ADDENDUM NO. 2  
TO  
CONTRACT DRAWINGS AND SPECIFICATIONS

MAINE TURNPIKE AUTHORITY  
ADMINISTRATIVE BUILDING  
CONTRACT NO. 2007.07

A/E PROJECT NO. 06016

PROJECT: MAINE TURNPIKE AUTHORITY  
 ADMINISTRATION BUILDING  
 SUBJECT: ADDED A4/AE543  
 SECTION DETAIL @ STAIR LANDING

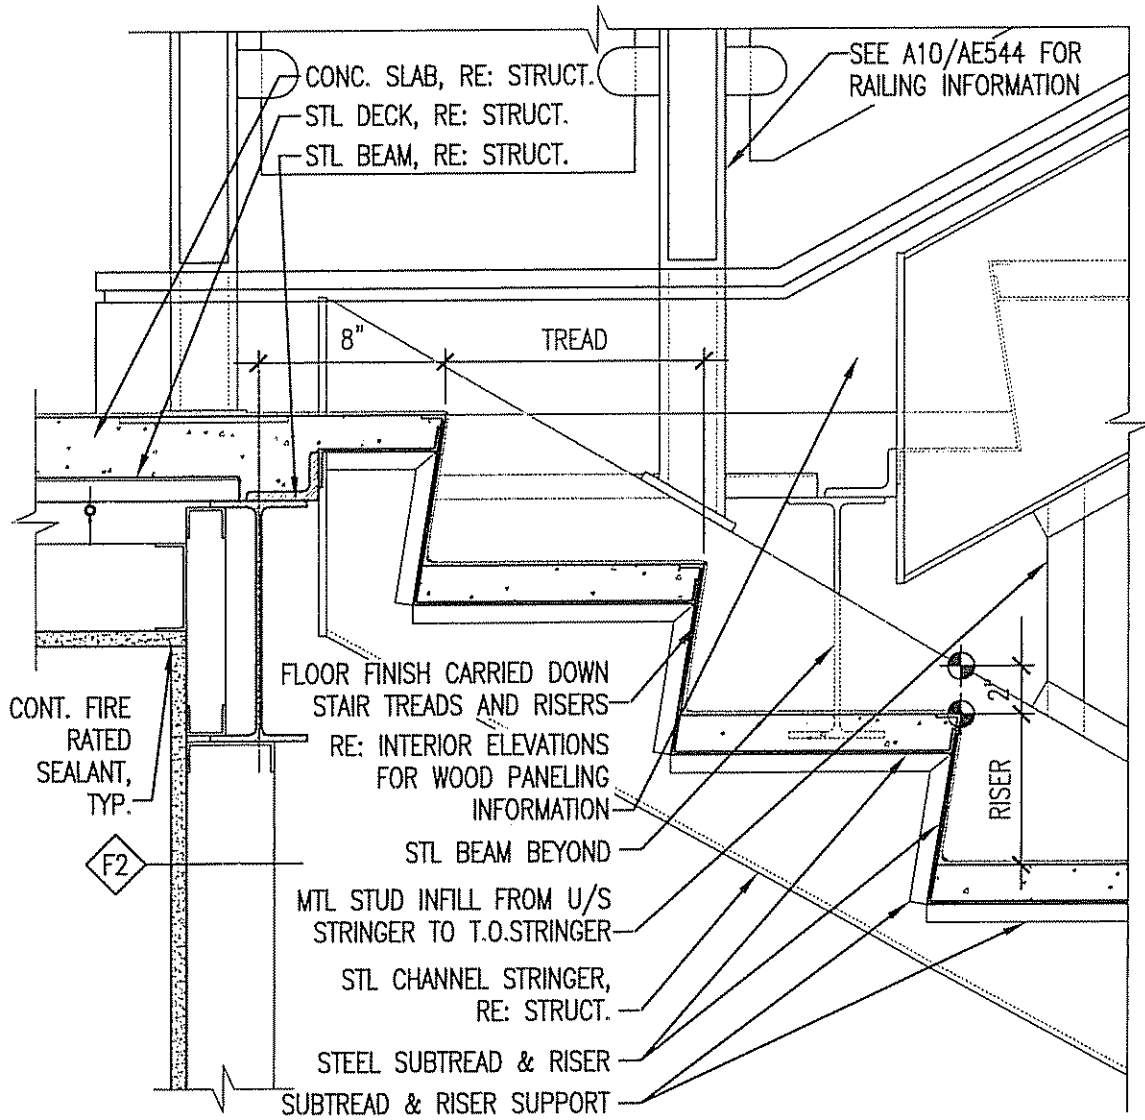
7. AE541 – STAIR SECTIONS & DETAILS:
- a. A1/AE541: Revise detail reference E4/AE543 to J4/AE543.
8. AE543 – STAIR DETAILS:
- a. Add details A4/AE543 – “Section Detail @ Stair Landing” and E1/AE543 – “Section Detail @ Top of Stair” included herein as Sketches No. A-1 and A-2.
